Application ref: 2024/5812/PRE
Contact: Ewan Campbell
Tel: 020 7974 5458
Email: Ewan.Campbell@camden.gov.uk
Date: 07/02/2025

Pre-application Medium Development Pre-application Advice Issued

Land west of Ashley Court (Frognal Garages)
Frognal Lane
London
NW3 7DX

Proposal: Follow up from 2024/4872/PRE - Demolition of existing garages and the erection of 7 x dwellinghouses (Class C3) with excavation of basement, associated amenity space, three new garage spaces, front and rear landscaping and associated works.

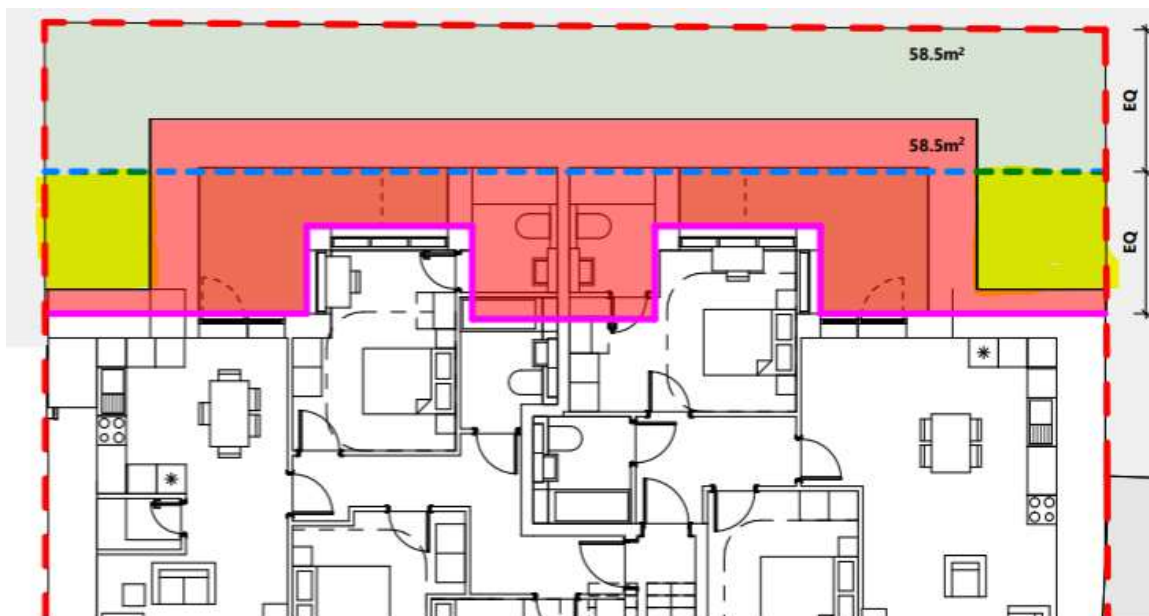
- There is a concern that this will harm any work gone into creating a well-designed building and needs to be adequately addressed. In the meeting it was discussed that reducing the amount of proposed units could alleviate some of the pressure and requirements for the small front area. One option would be to create duplex units on the ground and basement level and reduce the size of the basement. However, this may not have a significant impact on the requirements for the front area to provide cycle and bin storage, but it is worth exploring.
- This was raised at length in the meeting and an amended drawing has been submitted to try and address the issues raised. On the left below is the original ground floor design and on the right is the amended design

- The two drawings show very little difference, if any, and therefore has not addressed the concerns raised. The small increase of planting next to the cycle parking does not successfully address this. Looking at incorporating some of the space internally or reducing the number of units on site will help with this.

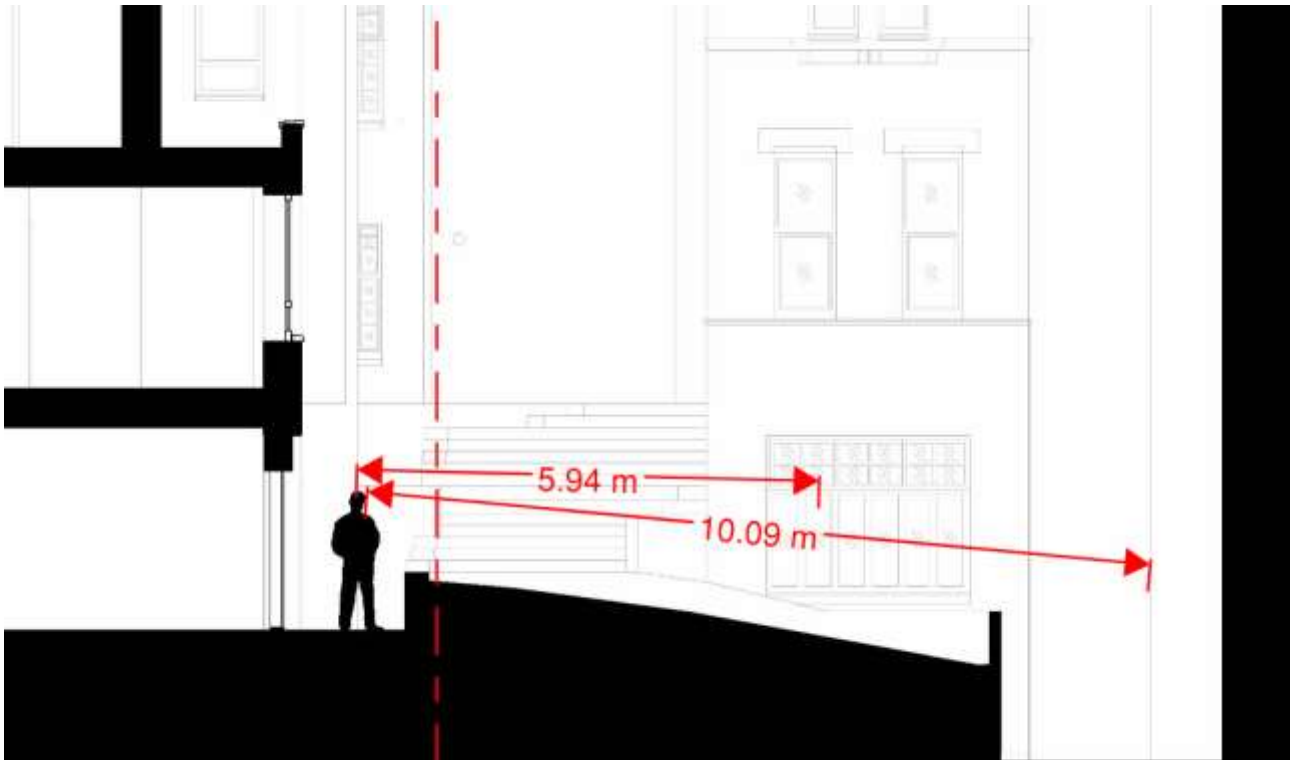
The basement has been amended to include a larger lightwell to the front which provides more amenity space and better light into the basement. The pack recognises this exceeds point h of policy A5 with the graphic below:

With the blue line indicating the 50% of the garden, the small increase is considered acceptable.

Within the pre-app it was discussed about excavating further the yellow highlighted sections to create storage space. This goes some way of improving the quality of accommodation it is only minor and can probably be subsumed into the existing floorplate; the lightwells and excavation should be more focused on getting light into the flats but also improving the front landscaping. Is there an option to reduce the depth of the lightwells and increase their width? This could provide a solution and officers would recommend looking into this.

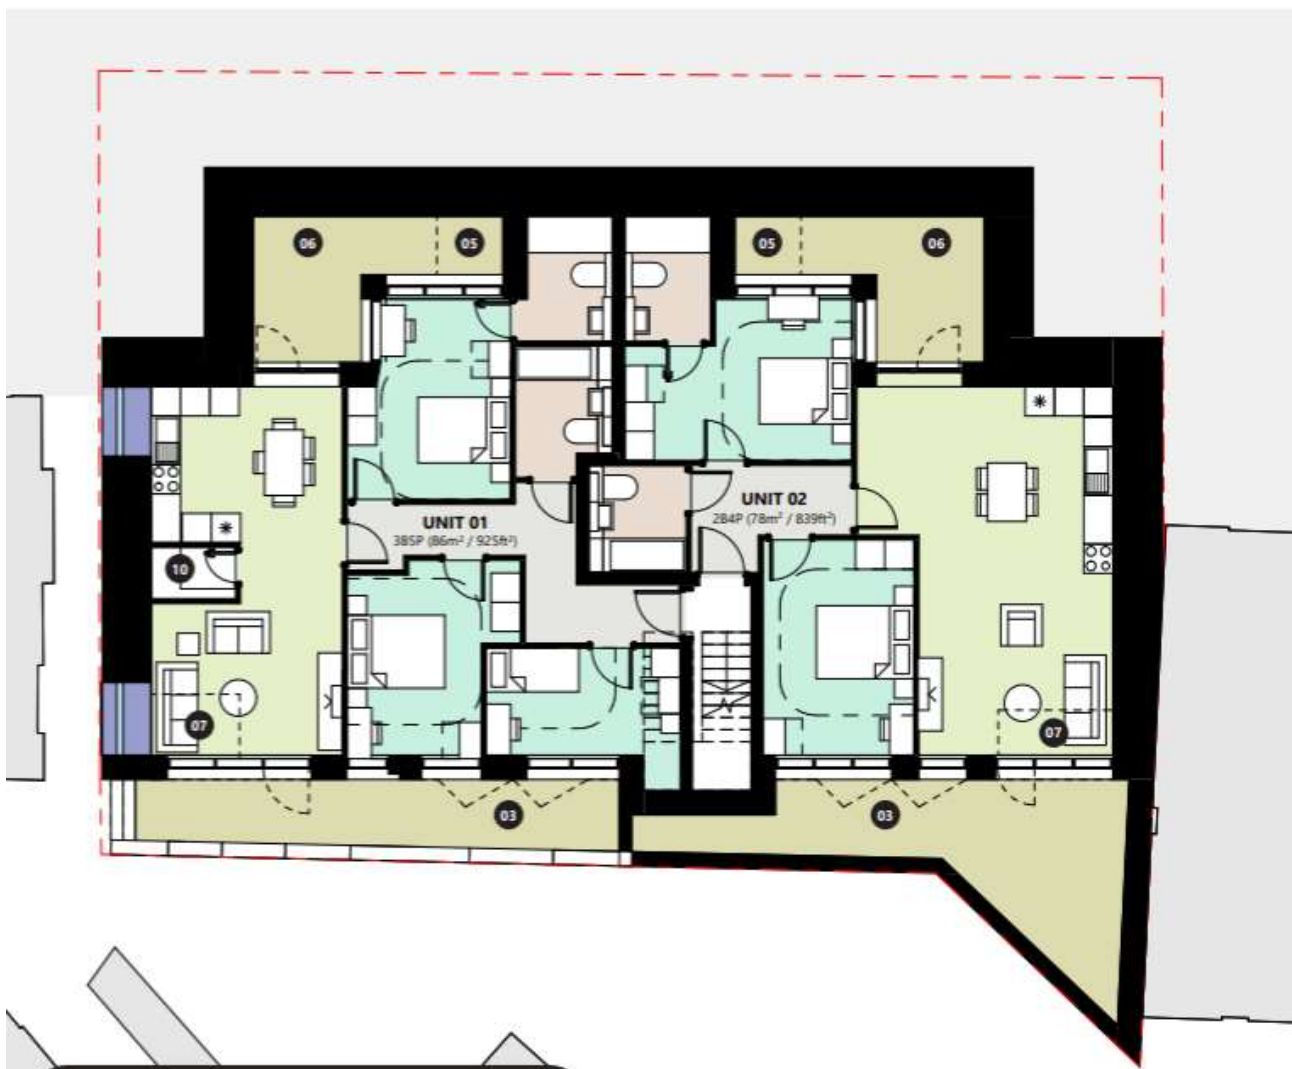
The terraces have been moved but the privacy screen at basement level has also been removed which appears to make the relationship worse. The Council has asked for various sections, CGIs and axo graphics to determine the nature of the relationship. One section has been provided which is below:

Due to the level change the proposed rear terrace sits above the rear of the properties which increases the impact on privacy and the perception of overlooking. Also the distances have got closer which further compounds the issue. The Council, at this moment, does not support this relationship and will need to be amended somehow. However, more detailed sections and drawings describing the relationship, and the uses of nearby rooms served by the windows, may help to alleviate some concerns.
